City of Ketchum

Recommendation to Approve the Onyx at Leadville Residence: Phase 3 Final Plat

A CONDOMINIUM PLAT SHOWING THE ONYX AT LEADVILLE RESIDENCE: PHASE 3

IN RE:)	
)	
The Onyx at Leadville Residence: Phase 3)	KETCHUM CITY COUNCIL
Final Plat)	FINDINGS OF FACT, CONCLUSIONS OF LAW, AND
Date: July 20, 2020)	DECISION
)	
File Number: P20-052)

SHEET 1 OF 3

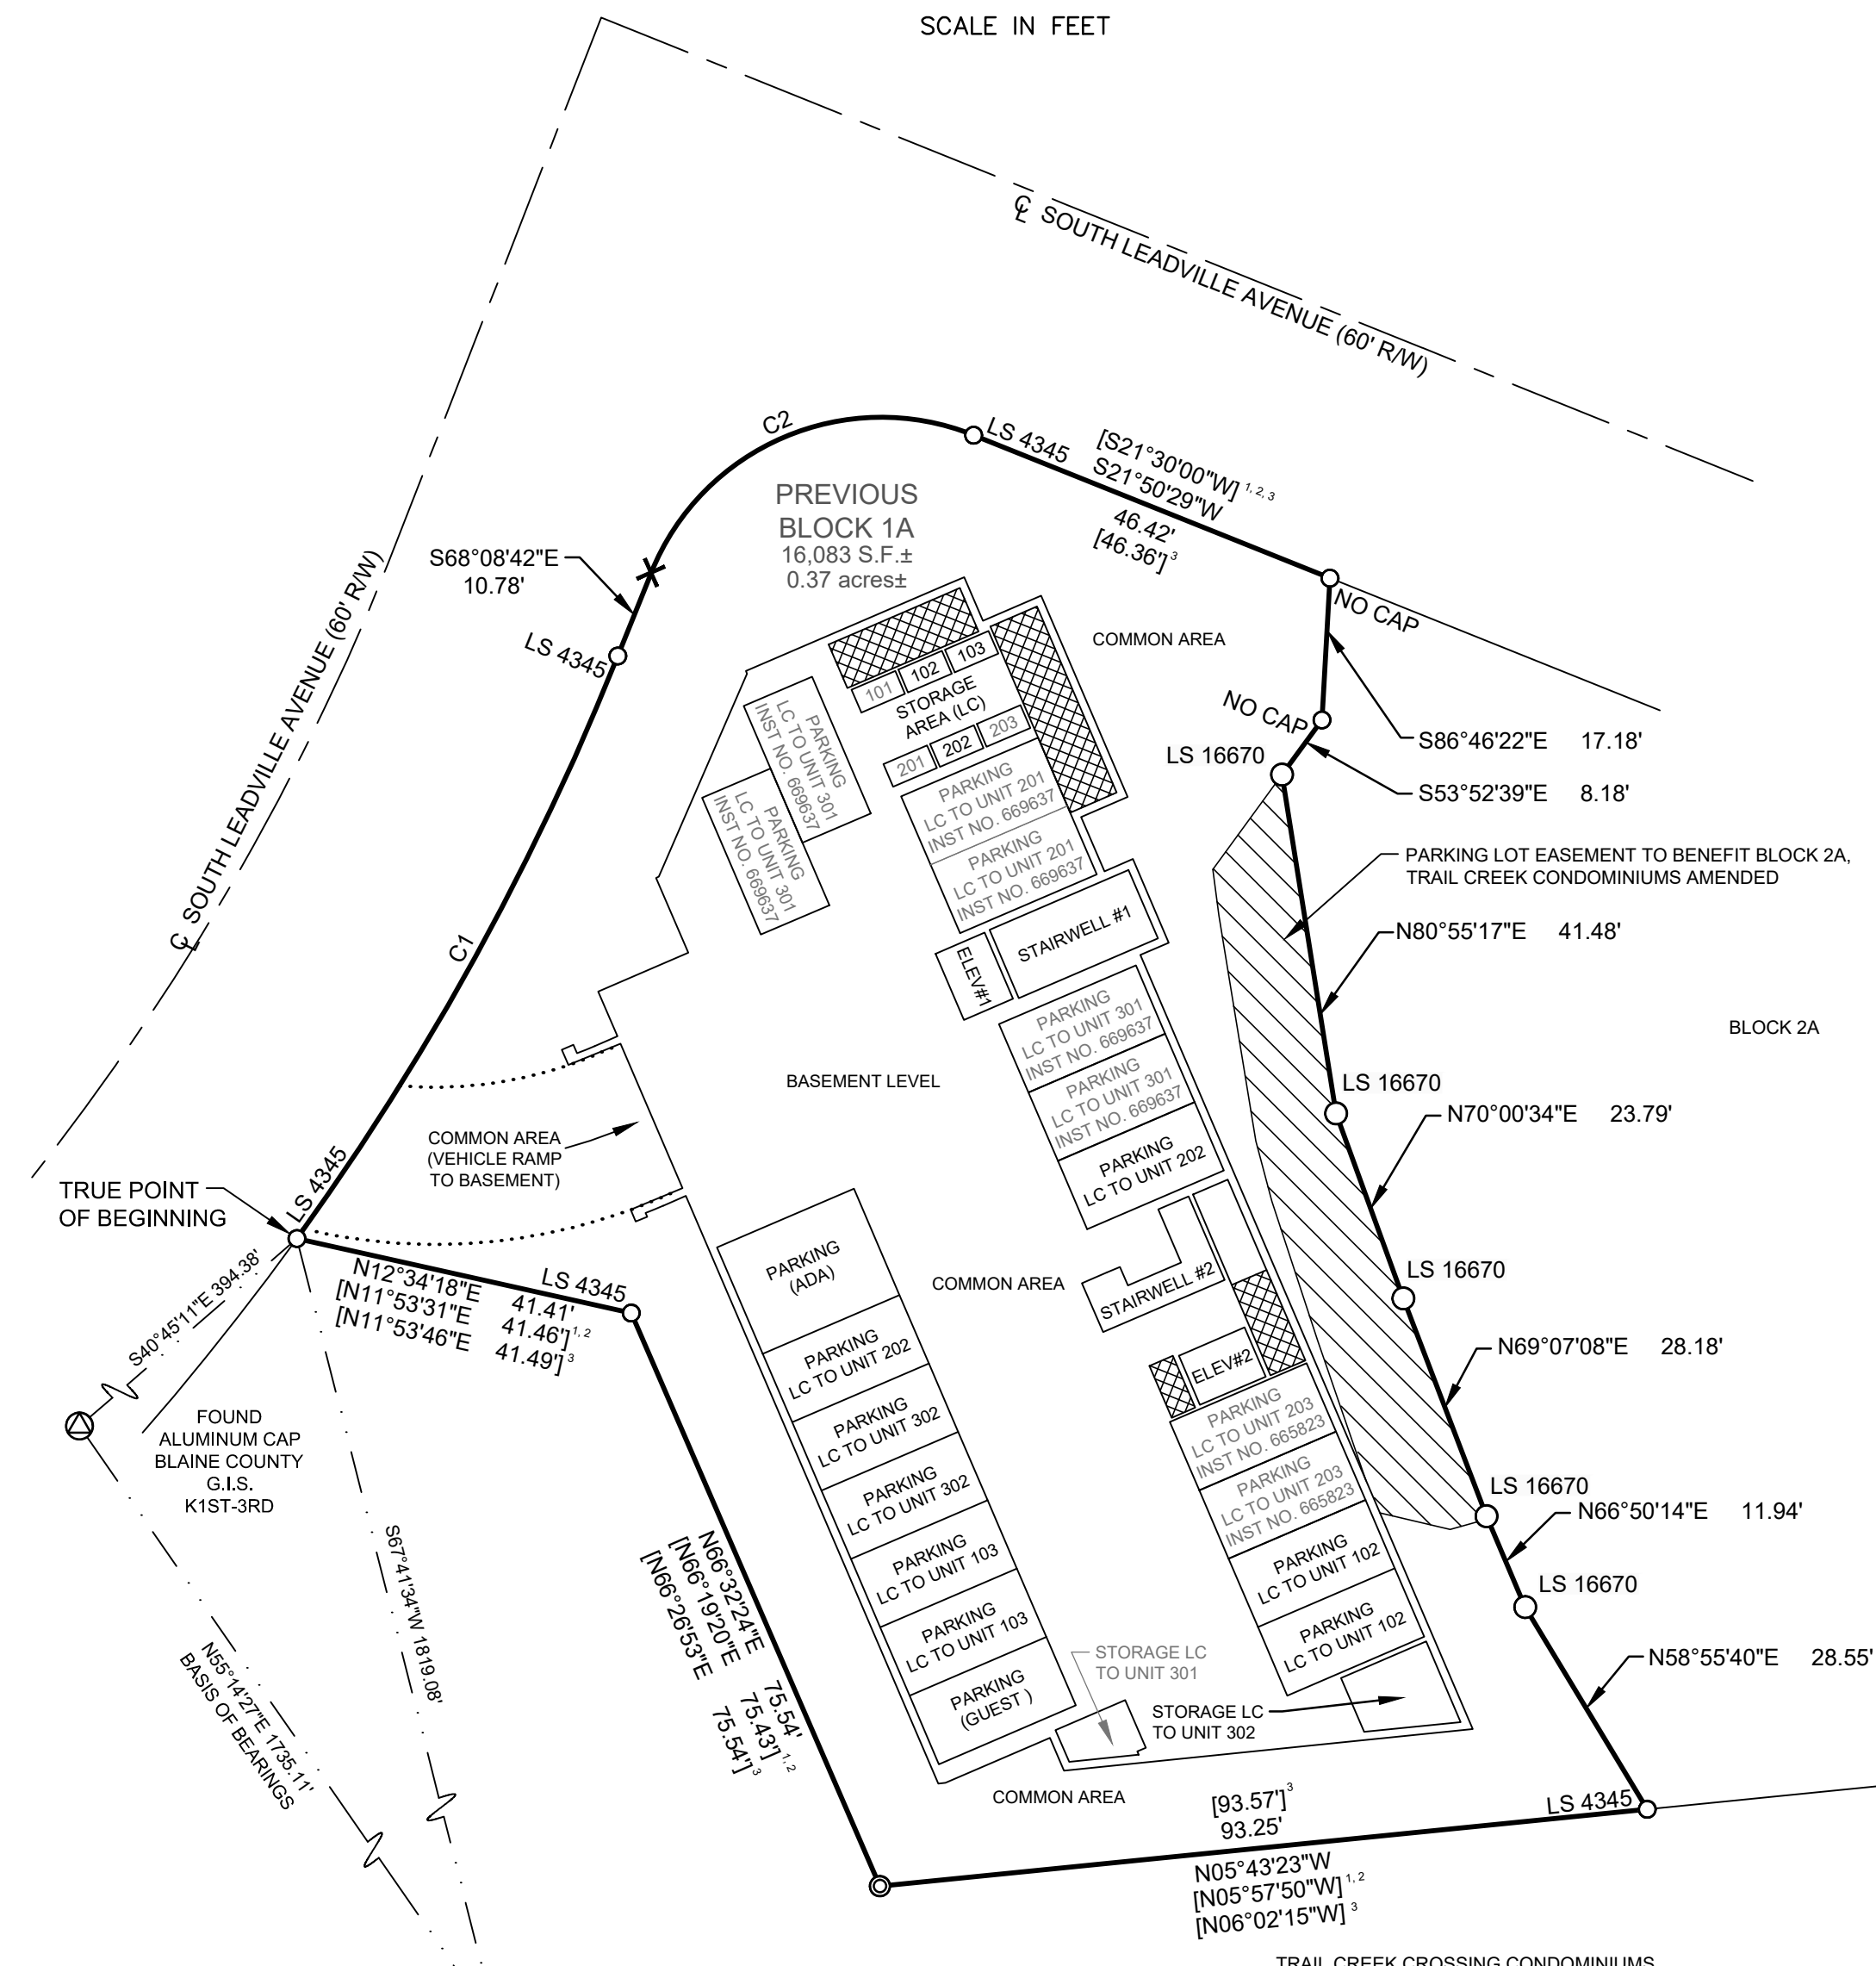
Staff Comments	<p><i>The Final Plat shall not be signed by the City Clerk until the Certificates of Occupancy for units 102, 103, 202 and 302 have been issued.</i></p> <p><i>A bond is in place for the right-of-way improvements. However, right-of-way improvements shall be completed prior to issuing Certificates of Occupancy for the four (4) units included in the Final Plat for Phase 3.</i></p> <p><i>The bylaws and condominium declarations were recorded simultaneously with the recording of the Final Plat for Phase 1.</i></p>
<input checked="" type="checkbox"/>	<input type="checkbox"/>	<input type="checkbox"/>	16.04.070.D	<p>Garage: All garages shall be designated on the preliminary and final plats and on all deeds as part of the particular condominium units. No garage may be condominiumized or sold separate from a condominium unit.</p>
			Staff Comments	<p><i>All underground garage parking spaces have been designated as limited common area tied to a specific condominium unit.</i></p>

Staff Comments	This standard has been met.
<input checked="" type="checkbox"/>	<input type="checkbox"/>	<input type="checkbox"/>	16.04.030.K.4	Names and locations of all adjoining subdivisions.
			Staff Comments	The adjacent Trail Creek Crossing Condominiums has been noted on the plat.
<input checked="" type="checkbox"/>	<input type="checkbox"/>	<input type="checkbox"/>	16.04.030.K.5	Name and right of way width of each street and other public rights of way.
				This standard has been met.
<input checked="" type="checkbox"/>	<input type="checkbox"/>	<input type="checkbox"/>	16.04.030.K.6	Location, dimension and purpose of all easements, public or private.
				As conditioned, this standard shall be met. The applicant shall include the following items on the Final Plat mylar: (a) visually represent the 5 ft public utility easement as required pursuant to KMC 16.04.030.J10, (b) certifications, (c) certificate of owners, (d) surveyor approval, and (e) agency approvals.

1. Approval of the Condominium Subdivision Preliminary Plat is subject to Design Review P18-005 and Building Permit B18-016. All conditions of approval shall apply. All City Department conditions shall be met prior to issuance of Certificates of Occupancy for Units 102, 103, 202 and 302.
2. The Final Plat mylar shall visually represent the 5 ft public utility easement as required pursuant to KMC §16.04.030.J10.

4. The recorded plat shall show a minimum of two Blaine County Survey Control Monuments with ties to the property and an inverse between the two monuments. The Survey Control Monuments shall be clearly identified on the face of the map.
